**Amendment to Final Drainage Plan  
Fawn Grove at Sunset Lakes Addition  
February 11, 2004**

# DRAINAGE PLAN FAWN GROVE AT SUNSET LAKES WICHITA, KANSAS

# LOT GRADING PLAN FAWN GROVE AT SUNSET LAKES WICHITA, KANSAS

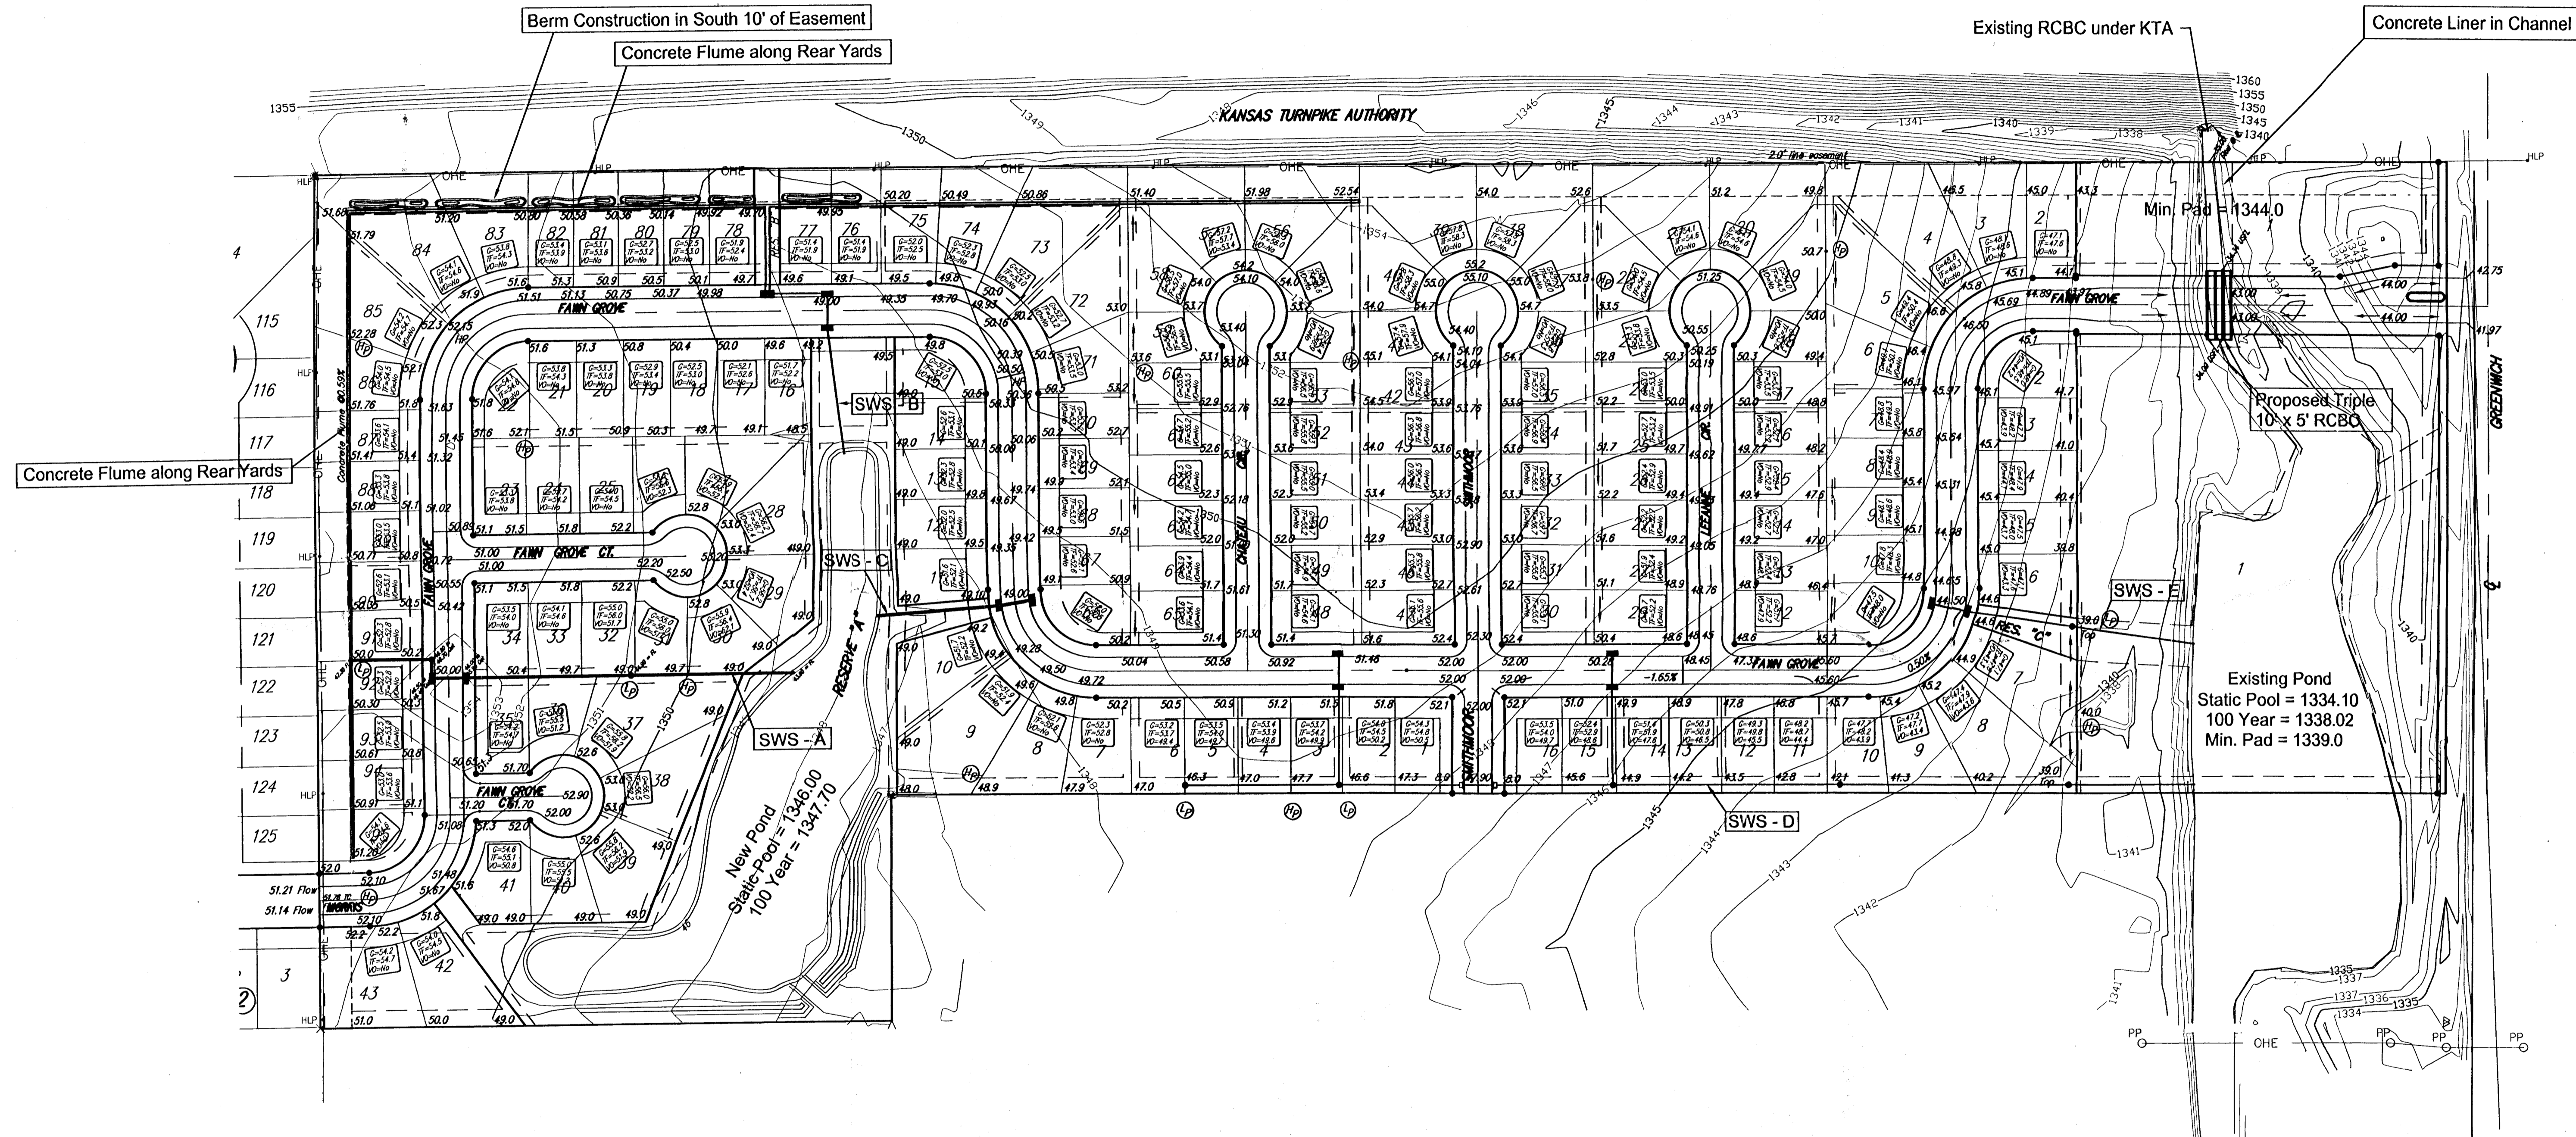
On February 10, 2004, it was decided to utilize a 3-10x5' RCBC under Fawn Grove, west of Greenwich. This RCBC can pass the 100-year storm event from the entire drainage basin from the north. Future Greenwich Road Improvements will address the need for the bypass RCBC from Gilbert and the KTA box to a point of outfall in the Fawn Grove pond system.

The drainage plan and lot-grading plan have been revised to reflect these changes (dated 2-11-2004), and are included with this amendment.
